AIA[®] Document G710[™] – 2017

Architect's Supplemental Instructions

PROJECT: *(name and address)*
57-21113-00 - Rebid Dutchess Stadium
New Left Field Clubhouse, Seating Bowl,
& Restroom Building

ASI INFORMATION:
ASI Number: 005

AUDIOVISUAL WIRING DEVICE RCP - LEVEL 01 - AREA A
 SCALE: 1/8" = 1'-0"

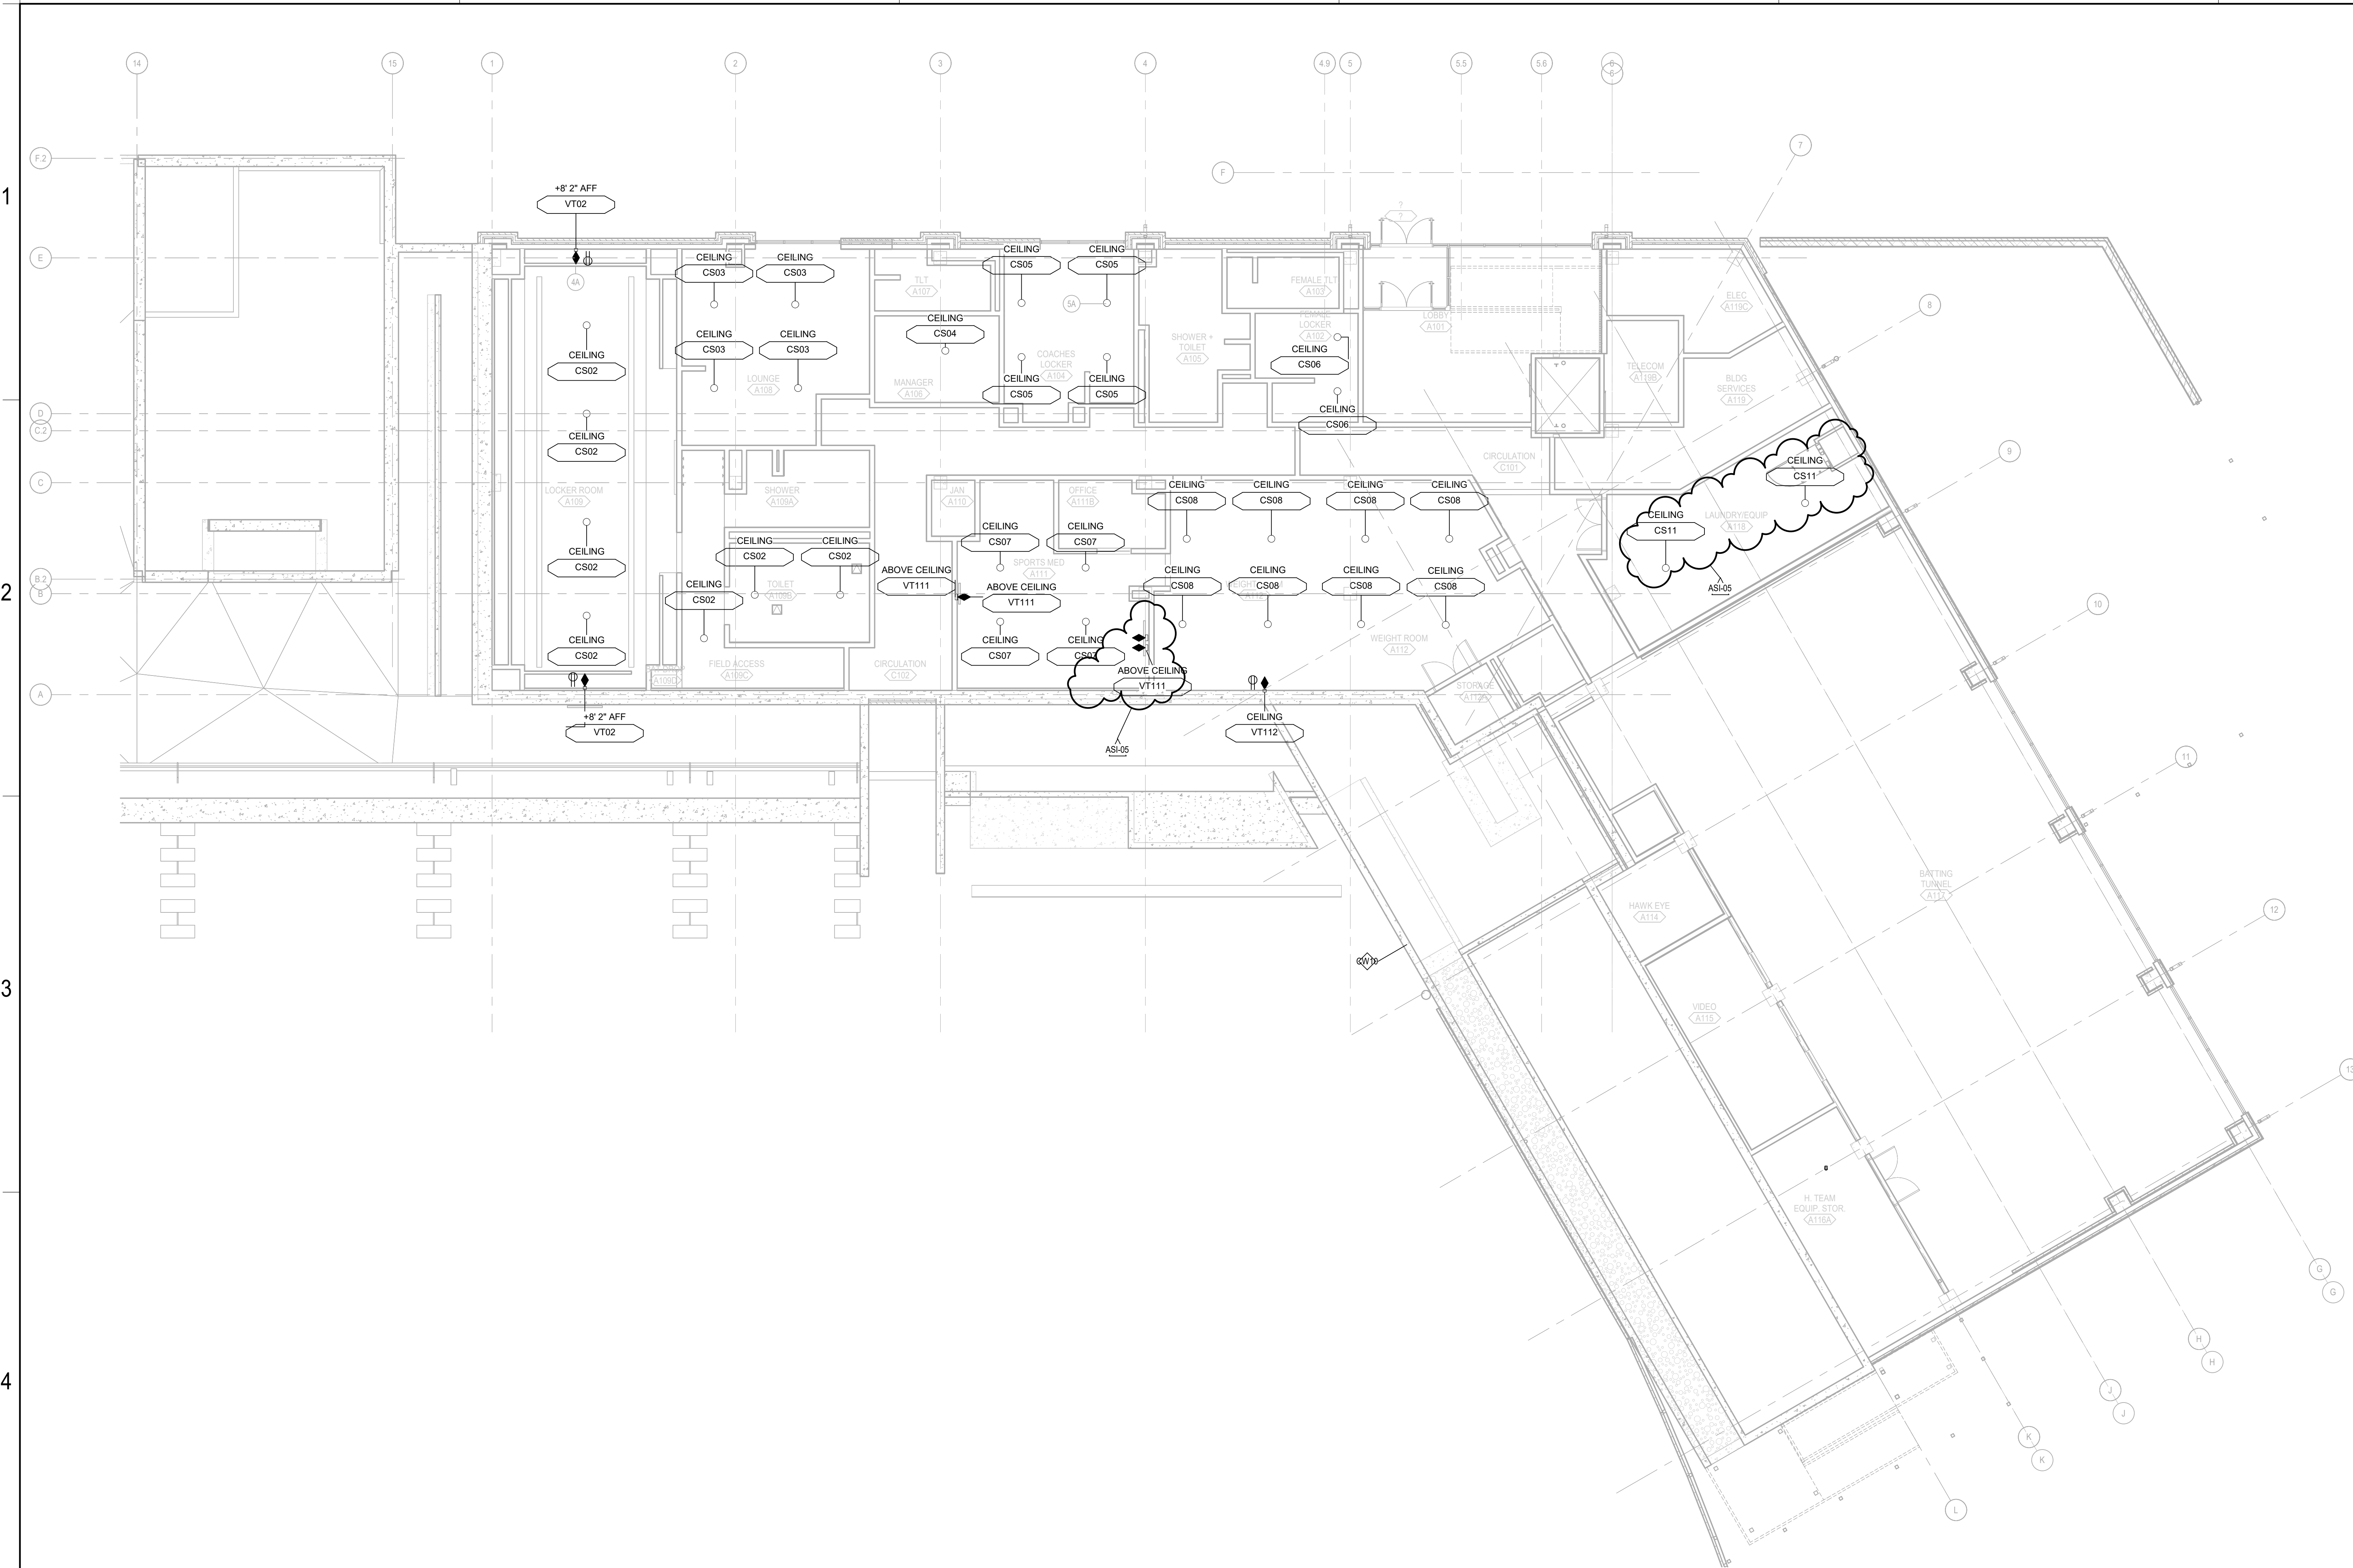
16. Sheet TA2.01A.ii - AUDIOVISUAL RCP, FIRST LEVEL - AREA A
 - a. Modifications per the attached sheet.
17. Sheet TA2.02A.ii - AUDIOVISUAL RCP, SECOND LEVEL - AREA A

57-21113-00
 AUDIOVISUAL EQUIPMENT RCP, FIRST LEVEL - AREA A
TA2.11A.ii

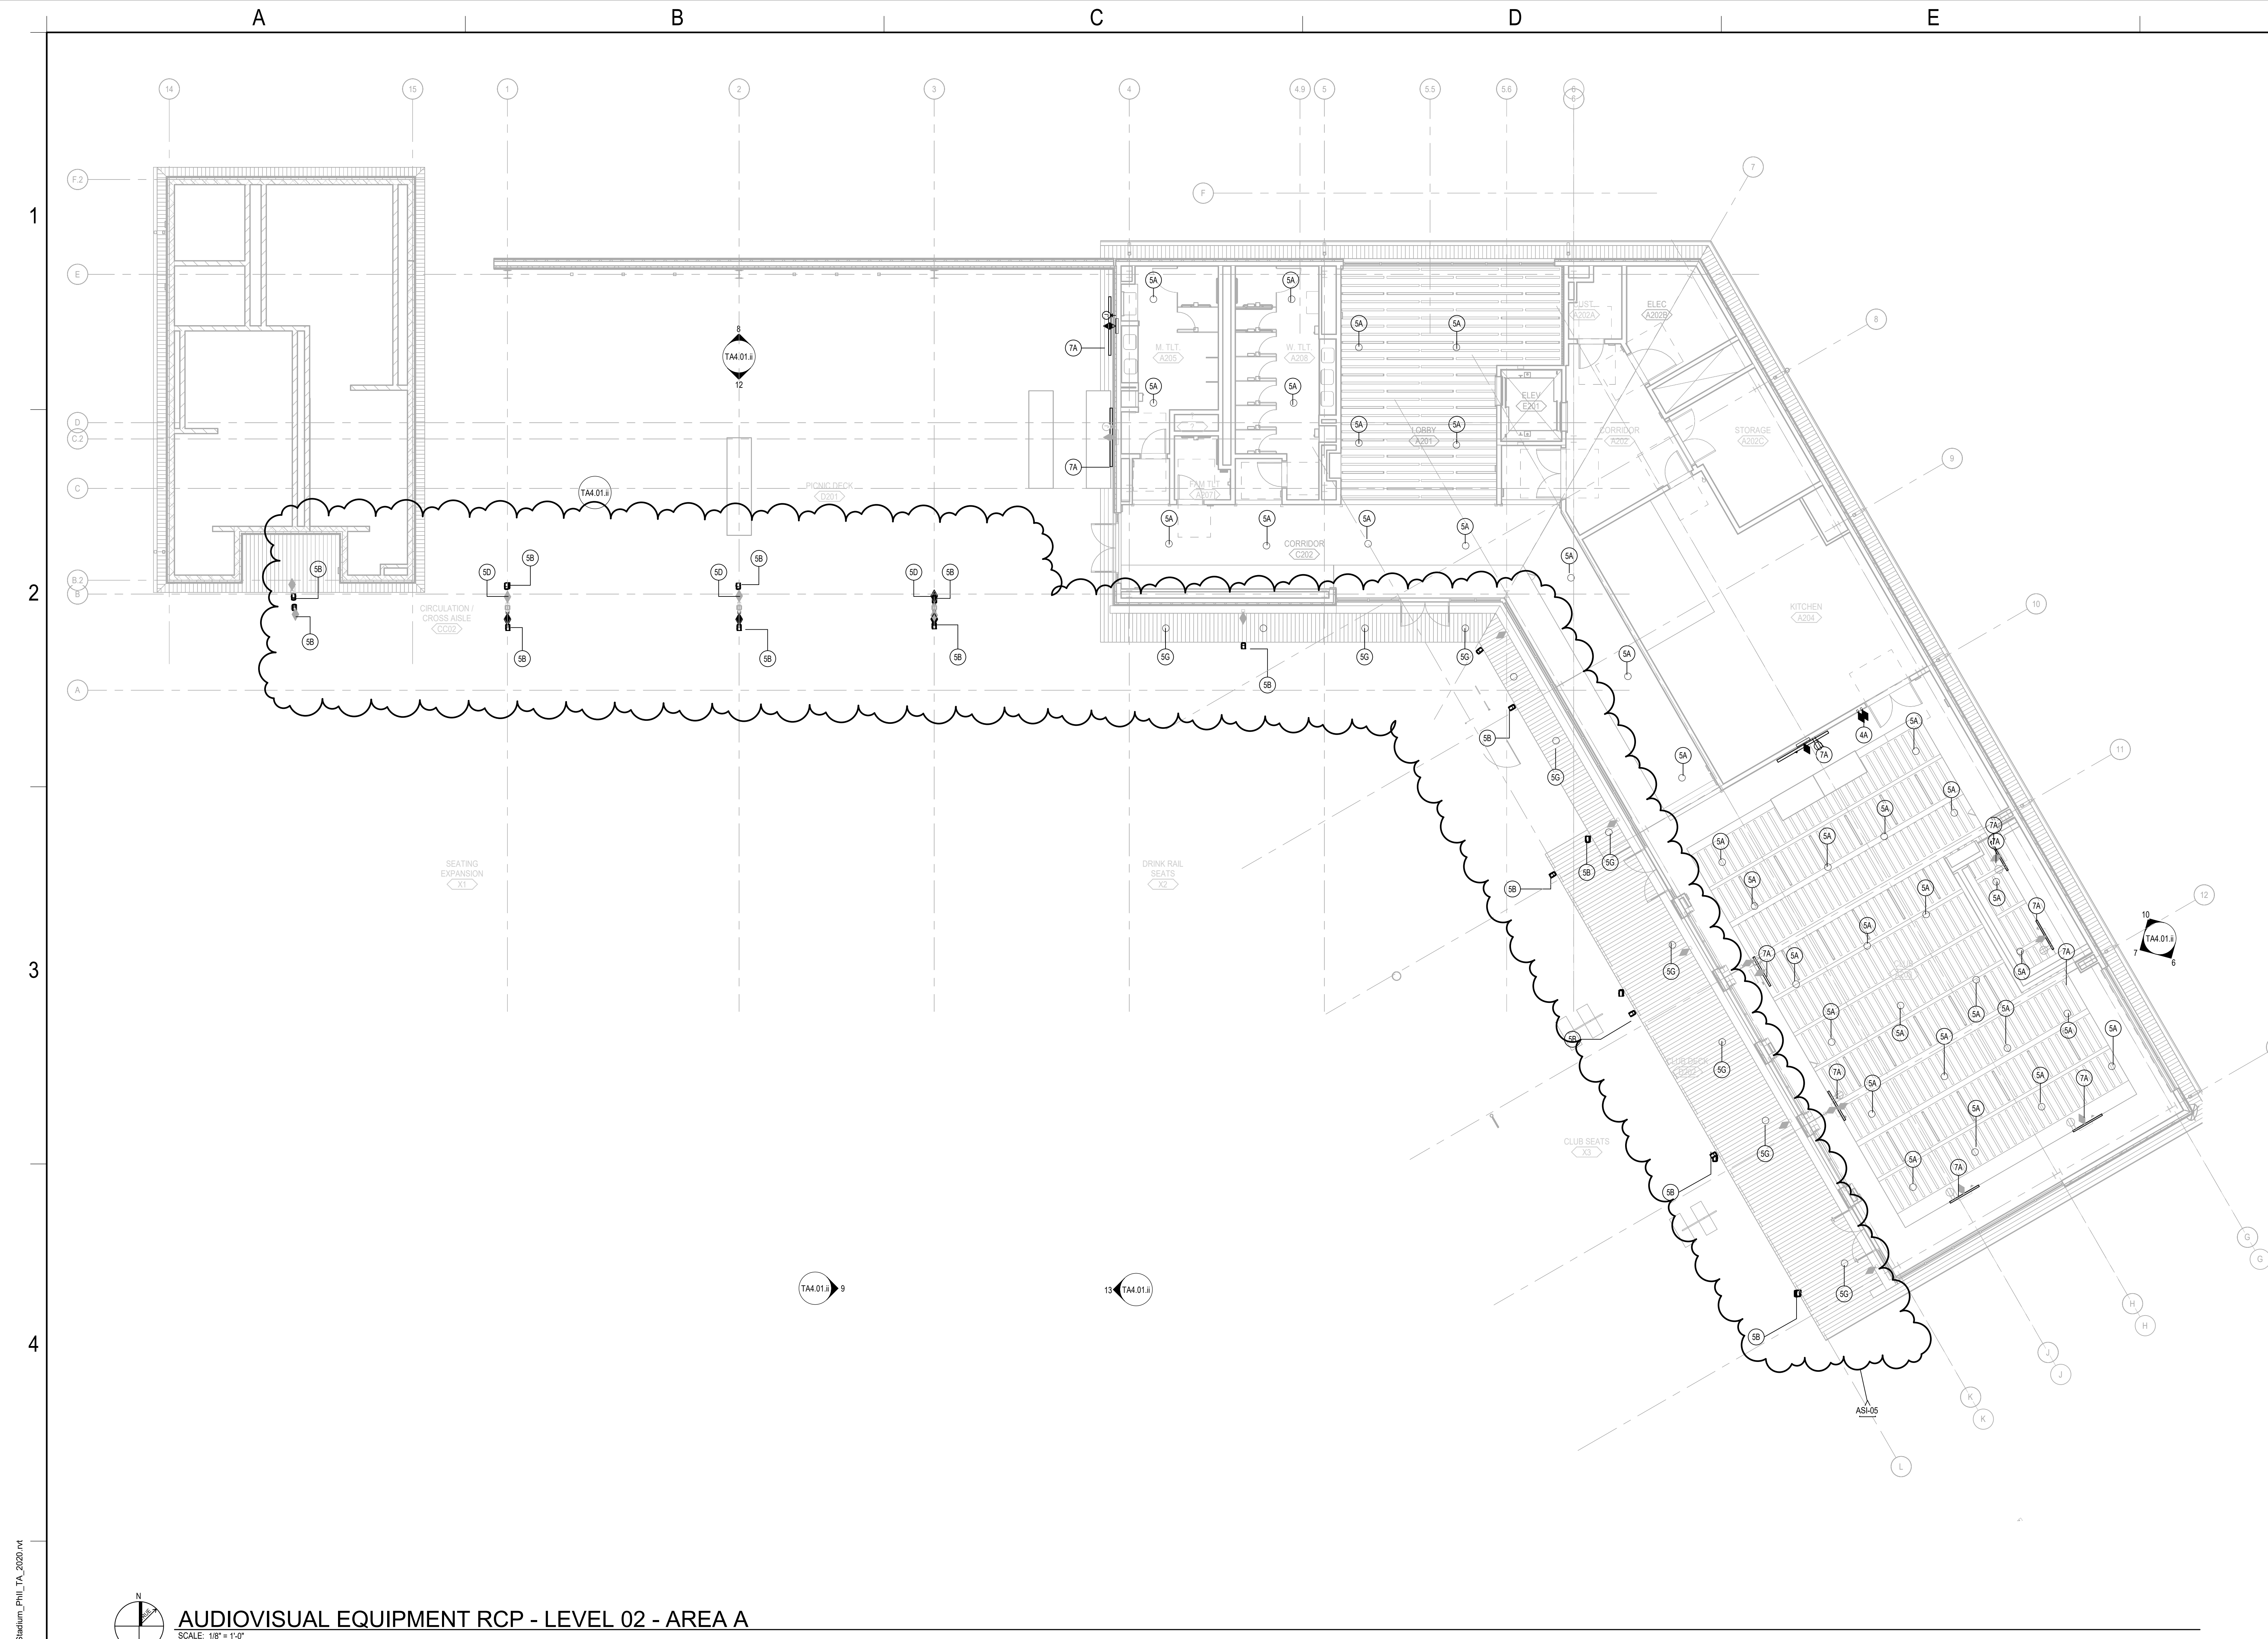
- a. Modifications per the attached sheet.
18. Sheet TA2.11A.ii - AUDIOVISUAL EQUIPMENT RCP, FIRST LEVEL - AREA A
 - a. Modifications per the attached sheet.
